## Planning Commission Staff Report

**Description:** **Spirit of St. Louis Airpark (18460 Olive Street Road):** A Site Development Section Plan, Landscape Plan, and Lighting Plan for a leasehold area zoned “M3” Planned Industrial District located on a 47.97-acre tract of land south of Olive Street Road at the intersection of Outlet Boulevard and Spirit Airpark East Drive (Ward 4).

**COMMENT RESPONSE  
LETTER**

The following responses are in reference to the review comments on the Site Development Plan for the proposed Spirit Sky Club Hangar Project

Figure 6: Parking Lot and Gate /Turning Radius Exhibit (Partial)

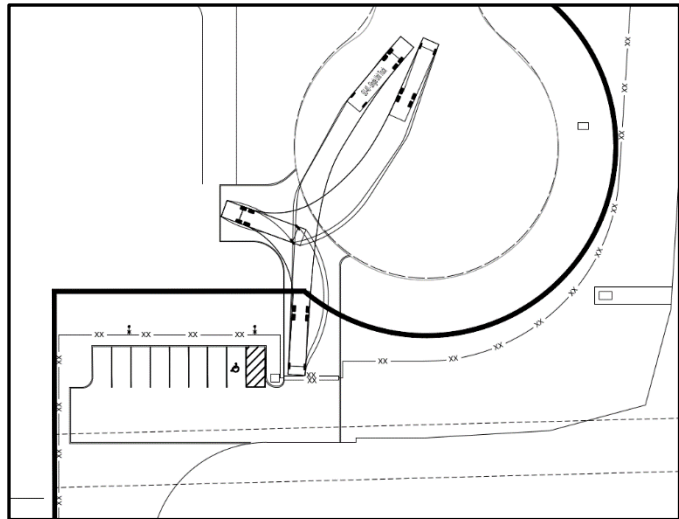
The site will be accessed from the cul-de-sac on Spirit Airpark East Drive and all associated parking and taxi lines will be gated from the public, see figure 6. The access to the site and turnaround at the end of the cul-de-sac exceeds the maximum allowed for maximum driveway width (allowed per code 40', proposed 46'); however, the entrance is located within the jurisdiction of St. Louis County Department of Transportation and the access and turnaround have been approved by the County. There is a fuel tank located on the west side of the northern most hangar building in the complex and the proposed flatwork will include three connecting drives to the taxi lane to the east and aircraft can enter the hangars on both the north and south side sides of each building.

Figure 7: Partial North Elevation

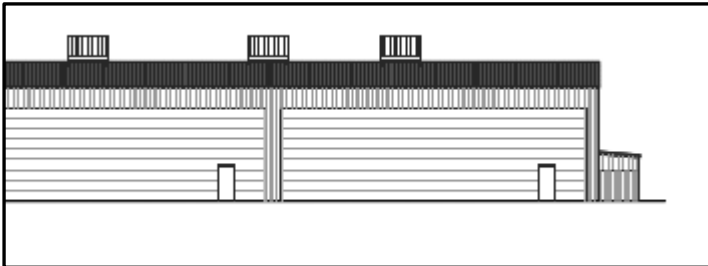
This project was reviewed by the Architectural Review Board on May 9, 2024 and the Board made a recommendation to approve with one condition. The condition was to change the color of the HVAC screening from “Charcoal” to “Polar White”. The applicant has since updated their elevations. The motion passed by a vote of 6-0.

1. **Comment** – Provide the updated colored elevations per the recommendation for approval by ARB on May 09, 2024.  
**Response: This has been included.**

**SITE PLAN**

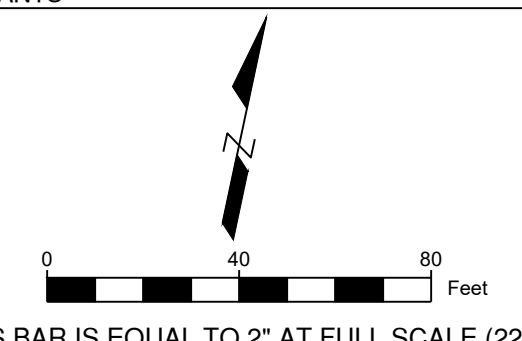
- (CC) PROPOSED RIP-RAP
- (PD) PROPOSED SIDEWALK SHOWN ON FRONTAGE OF LEASED AREA. REQUESTED TO BE REMOVED PER COMMENT RESPONSE LETTER
- (PE) PROPOSED STACKING DISTANCE IN FRONT OF GATE = 60' LENGTH OF STRAIGHT SECTION = 43.3', LENGTH OF CURVE = 16.7'
